# REVIEW ON HYDROLOGY AND HYDRAULICS, AND SEDIMENT AND RIVER MORPHOLOGY

## FINAL DRAFT OF THE TECHNICAL REVIEW REPORT FOR SANAKHAM HYDROPOWER PROJECT'S PRIOR CONSULTATION PROCESS

11<sup>TH</sup> REGIONAL STAKEHOLDER FORUM: 2<sup>ND</sup> REGIONAL CONSULTATION MEETING FOR PRIOR  
CONSULTATION OF SANAKHAM HYDROPOWER PROJECT

30 NOVEMBER 2021

# Pre-project monitoring & analysis

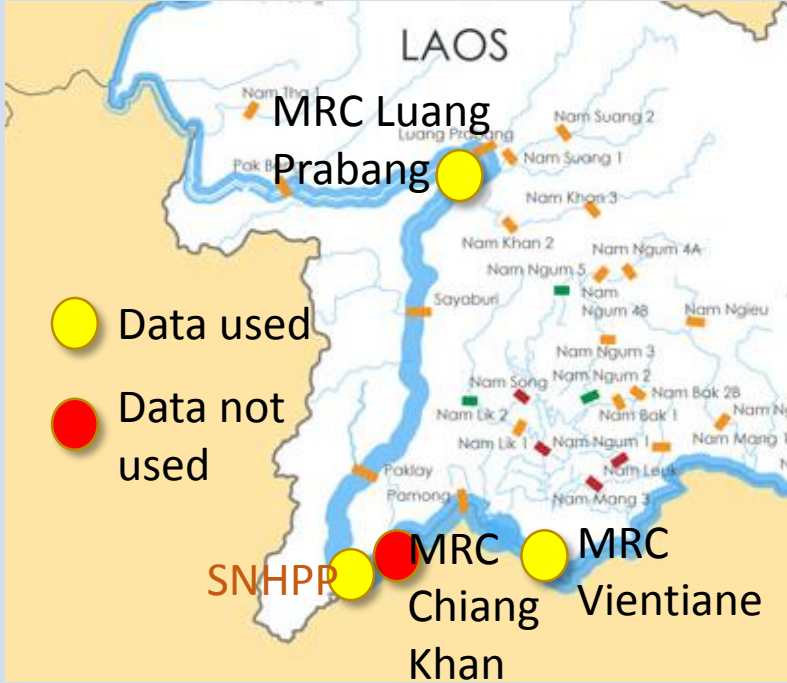
Data	Long-term data daily discharge at dam site (interpolation)	Discharge directly measured at dam site
	 <p>Map of the Lancang River basin in Laos showing dam locations. A legend indicates that yellow circles represent 'Data used' and red circles represent 'Data not used'. The MRC Luang Prabang site is marked with a yellow circle, while the MRC Chiang Khan site is marked with a red circle. Other sites like SNHPP, MRC Vientiane, and various Nam Suang, Nam Khan, and Nam Ngum dams are also labeled.</p>	 <p>Photograph of a river discharge measurement site. A person in an orange vest stands on the bank, while others are in a boat in the river. A vertical measuring staff is visible in the foreground.</p>
Issues	<ul style="list-style-type: none"> <li>• Chiang Khan data not used for computing/comparing DAILY discharge</li> <li>• Only data until 2012 used: excludes impacts of upstream dams (present hydrology, influence Lancang and tributary dams)</li> <li>• Influence of climate change not considered</li> </ul>	<ul style="list-style-type: none"> <li>• Accuracy of data cannot be judged (no information on QA/QC or comparison with Chiang Khan)</li> </ul>

# Tailwater calculations

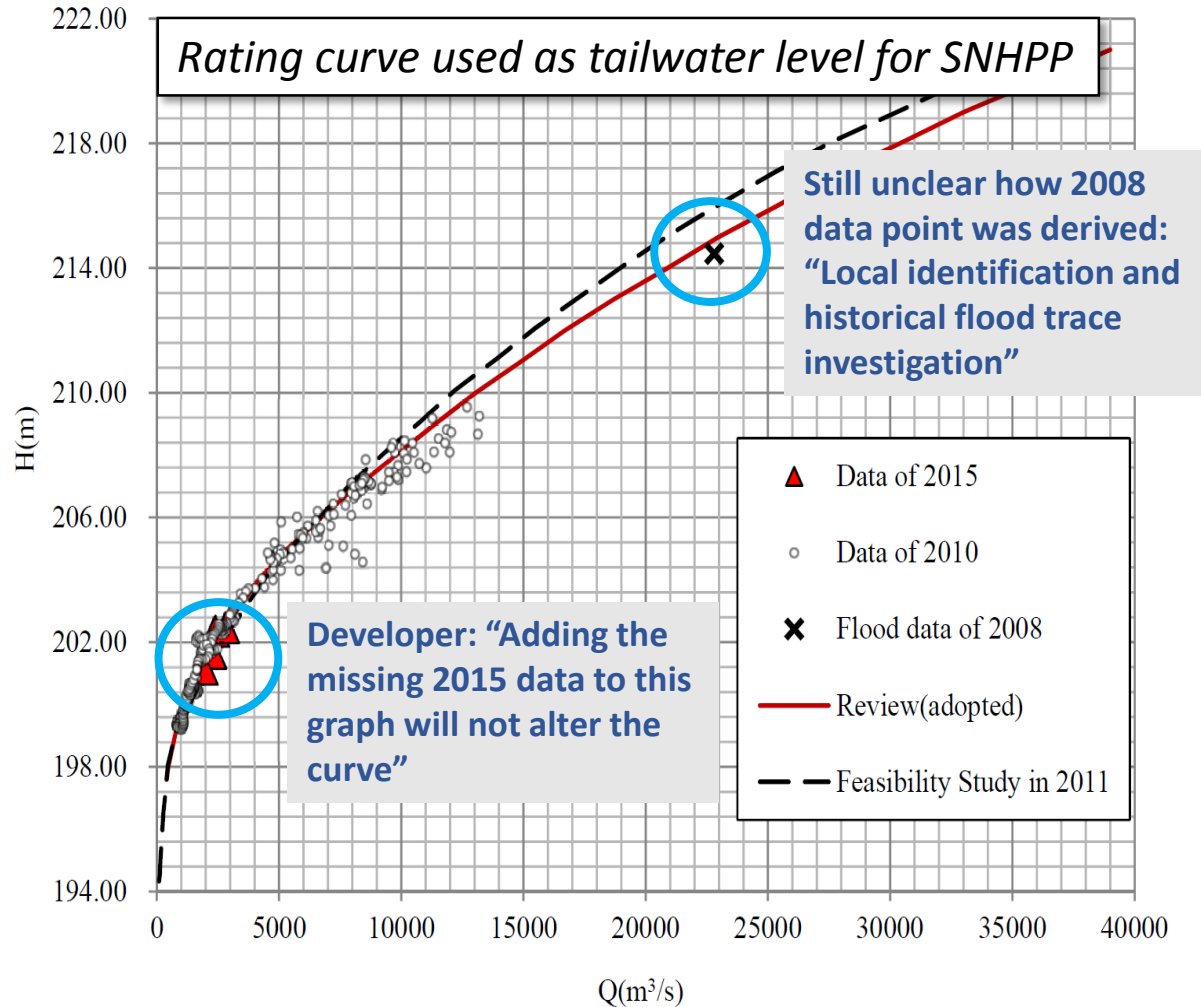
**Relevant issue: Riverbed downstream will erode, which will lower the tailwater. This will in turn affect the design of the navigation lock and fish pass entrances.**

## RESERVOIR OPERATION RULE

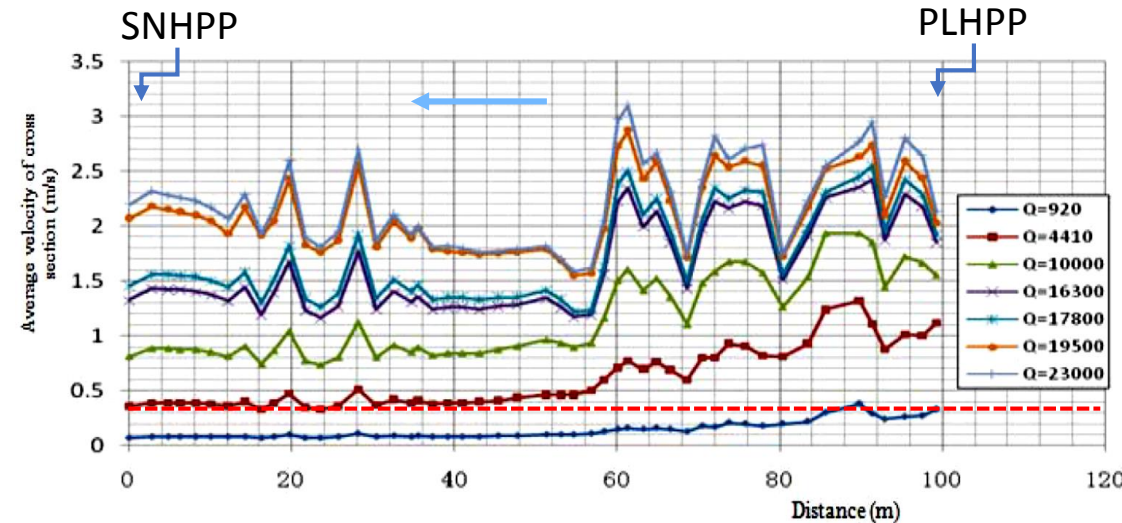
- Consideration and mitigation of downstream environmental impacts by station operations is essential but missing (direct transboundary impact)
- Decreased velocities in impoundment will impact fish larval drift ( $V < 0.3$  m/s, about 65% of time): needs to be addressed
- What will be done with Pak Lay (peaking) fluctuations?

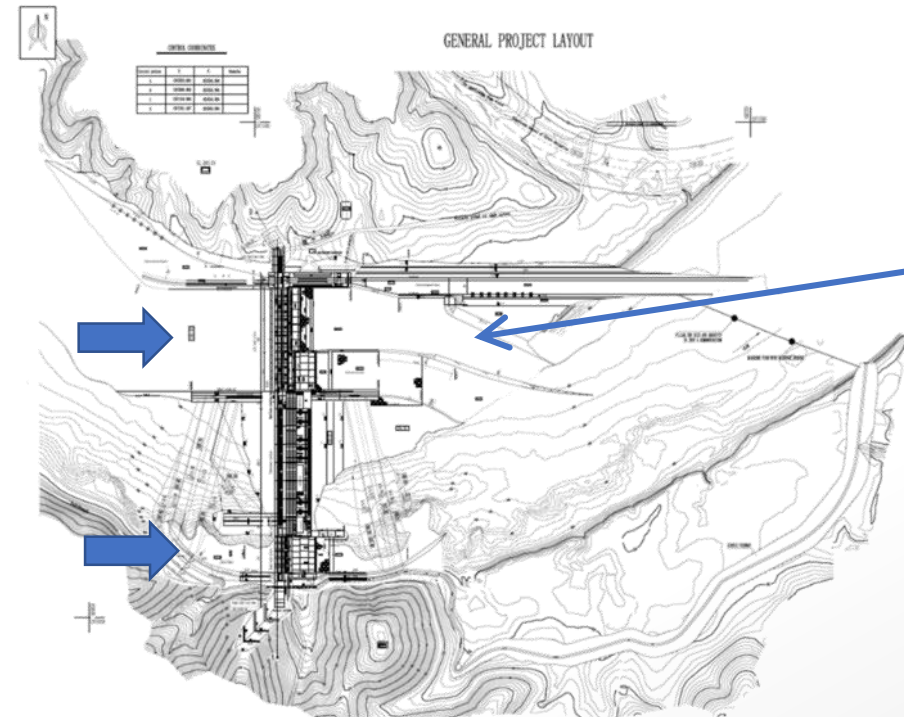
- Some issues were raised on complex flows at the structure and in the reach downstream, and on proposed design of downstream energy-dissipation and scour protection

Flow concentrates in inner bend, unevenly distributed over the gates

Scour protection designed for T 1/100 year only (dam safety)

# Sediment data used by developer

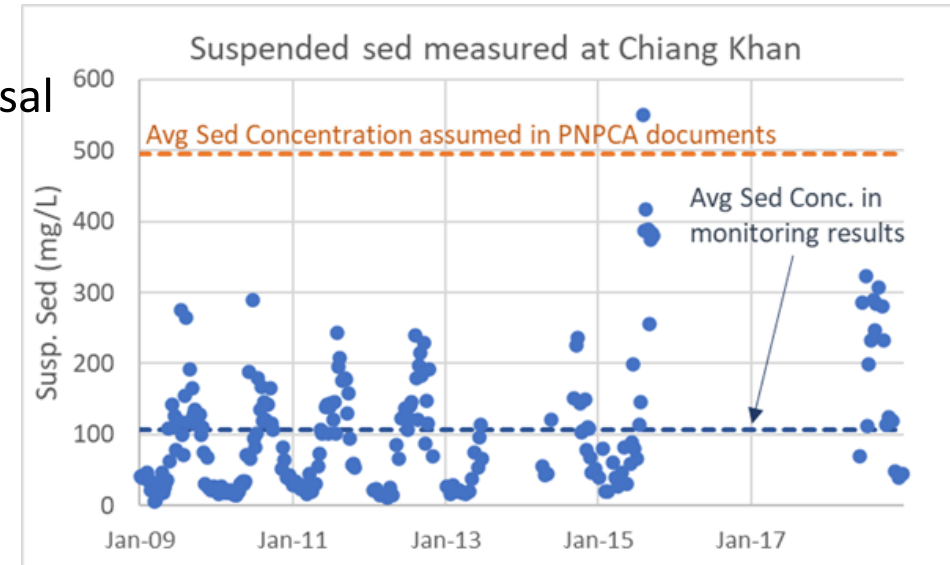
- ▶ Developer (2016) & MRC (2009 -2019) have measured sediment loads of 20 – 35 Mt/yr at SNHPP and Chiang Khan sites, respectively
- ▶ Developer uses sediment load of **69 Mt/yr** as basis for project proposal

- ▶ Based on old data (pre-Chinese & tributary dams)
  - ▶ 2.5 times greater than **ACTUAL** sediment load
  - ▶ Does not reflect current conditions
  - ▶ No consideration of future sediment reduction due to additional HPPs in cascade or tributaries

- ▶ **Use of inaccurate data affects ALL aspects of project and does not provide a valid basis for identifying potential transboundary impacts**
  - ▶ **Modelling is inaccurate because of inaccurate sediment loads**

- ▶ **Over-estimates sediment accumulation rates in impoundment**
    - ▶ **Under-estimates time until coarse sediment can be passed through dam to downstream river**

- ▶ **Inaccurate understanding of sediment deposition near infrastructure**

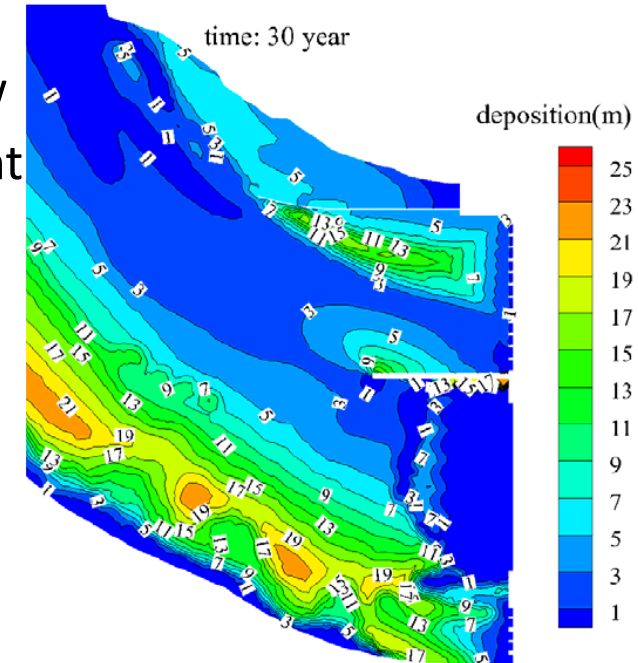
- 2-D modelling shows low velocity upstream of right bank gates
  - Low sediment transport
  - Sediment deposition upstream of gates

- Physical modelling shows passage of coarse sediment through dam, but only after 50 years of sediment accumulation
  - Likely to be far longer due to over estimate of sediment input
- Will result in decades to centuries of coarse sediment starvation downstream

Figure 4.3-29 Flow field upstream of the dam (scheme 5)

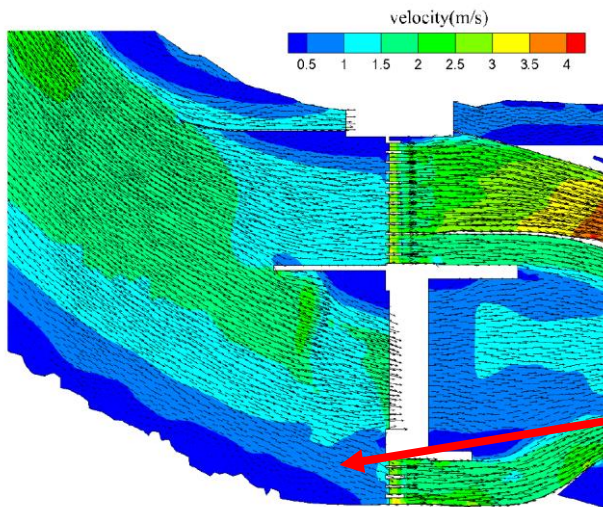
- Right gates have the lowest sill level and are aligned with the thalweg, but they are not aligned with **the main flow paths** through dam infrastructure – will not maximise sediment passage
- **Deep sediment deposits** required to accumulate in front of dam before bedload can be passed through gates >>50 years
- No detailed information or modelling results about sediment flushing
  - Drawdown of impoundment not proposed on regular basis
- No modelling of sediment passage through right bank gates alone
- No information about sediment management at cascade scale
  - Environmental risk of multiple projects flush sediment at the same time

*Low flow velocity in front of right gates*

*MRC modelling of sediment transport with and without cascade*

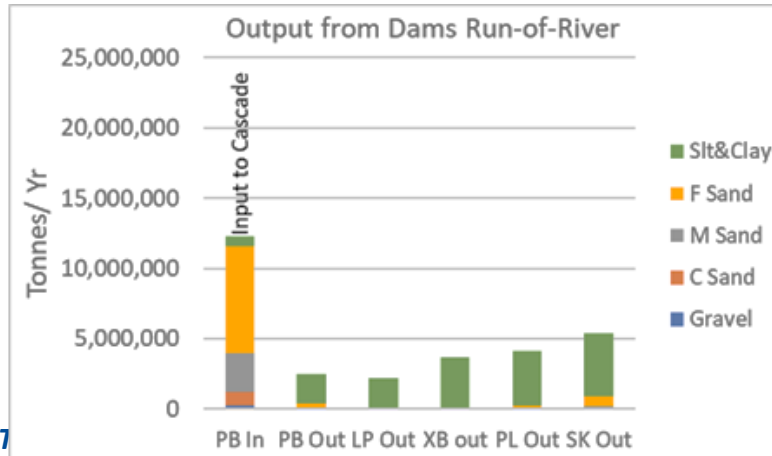
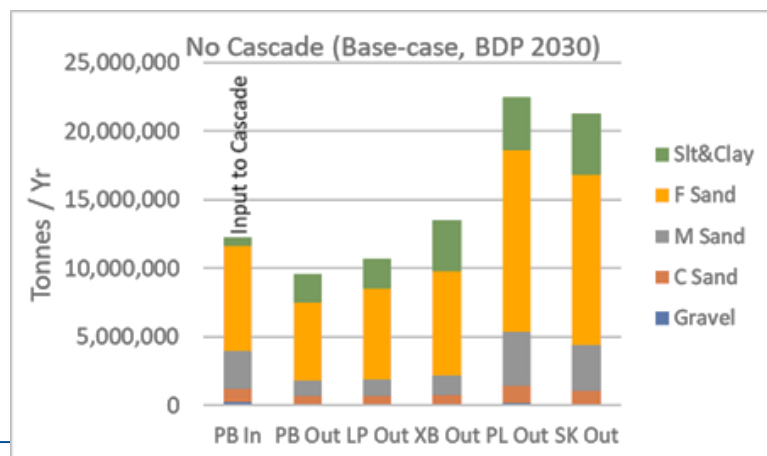
- ▶ Developer states 'little' change to sediment load due to project development
  - ▶ Based on inaccurate sediment loads
  - ▶ Grain-size distribution based on limited results & not from project location
    - ▶ *Under-estimates sand compared to long-term MRC monitoring*
  - ▶ MRC modelling shows large decrease in sediment load pre / post cascade
    - ▶ *Sediment loads at Sanakham decrease from 20 MT/yr to 5 MT/yr*
    - ▶ *Virtually all sand and gravel is trapped in impoundments*
    - ▶ *Erosional 'wave' predicted to move downstream of last dam in cascade*
- ▶ These changes will have substantial transboundary impacts – not addressed by developer
